Work Order ID 141873

Item Name: Baggage Compartment Protector - Floor And Wall

DART SERVICE INSTRUCTION

TO AMEND INSTALLATION INSTRUCTIONS IIN-D407-781-2 REV. A OR LATER APPROVED REVISION
AND INSTRUCTIONS FOR CONTINUED AIRWORTHINESS ICA-D407-781 REV. 3 OR LATER REVISION

**FIGURE 1 - D3879-1 BAGGAGE COMPARTMENT WALL
PROTECTOR - ALTERNATE INSTALLATION**

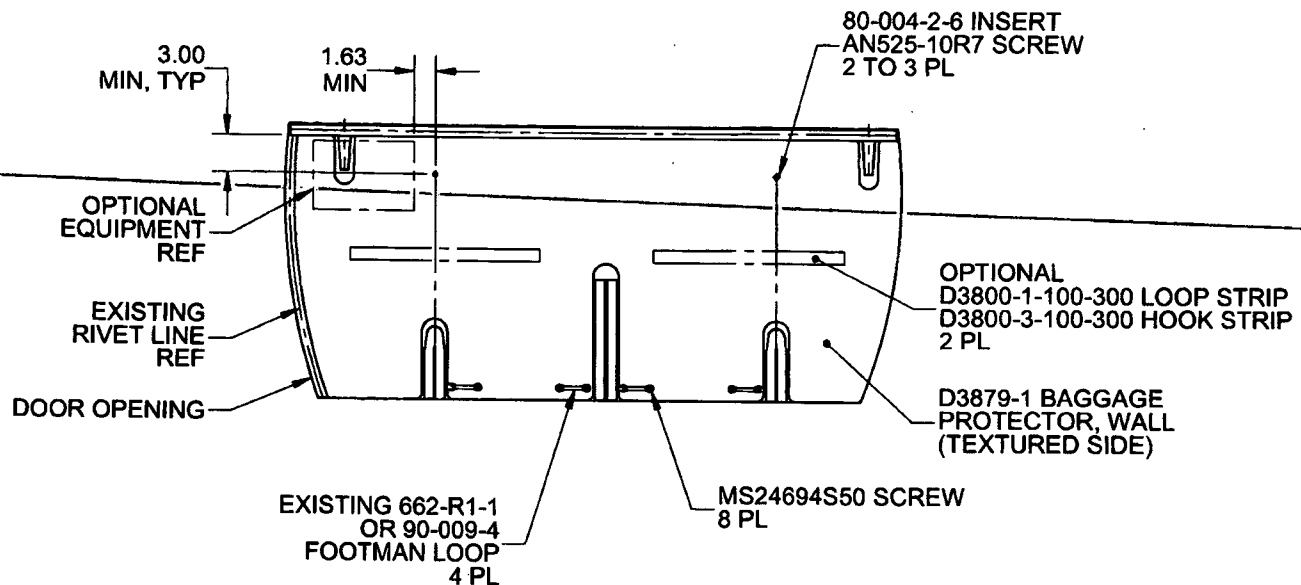
In some aircraft, the top portion of the D206-781-041 Baggage Compartment Wall Protector Kit cannot be installed as indicated in IIN-D407-781-2. The purpose of this DSI is to provide an alternate mounting method to fasten the top portion of the D206-781-041 Baggage Compartment Wall Protector Kit.

It is acceptable to replace qty(2) D3930-1 Clips with qty(2) 80-004-2-6 Inserts. Locate and mark location of the two attachment holes on the baggage compartment wall as shown in Figure 1 of this service instruction. Install 80-004-2-6 Inserts at the marked locations in accordance with Section 3-2-12 of BHT-206-SRM-1. It is acceptable to trim the wall protectors to accommodate optional equipment or transfer attachment holes to the wall protector and install the optional equipment on top of the wall protector with longer fasteners.

Amend the D206-781-041 Baggage Compartment Wall Protector Kit parts list as follows:

Qty -061	Qty -031	Qty -041	Part Number	Description
X			D206-781-061	BAGGAGE COMPARTMENT PROTECTOR KIT (FLOOR AND WALL)
1	X		D206-781-031	BAGGAGE COMPARTMENT FLOOR PROTECTOR KIT
1		X	D206-781-041	BAGGAGE COMPARTMENT WALL PROTECTOR KIT
		2	AN525-10R7	SCREW
		2	80-004-2-6	INSERT
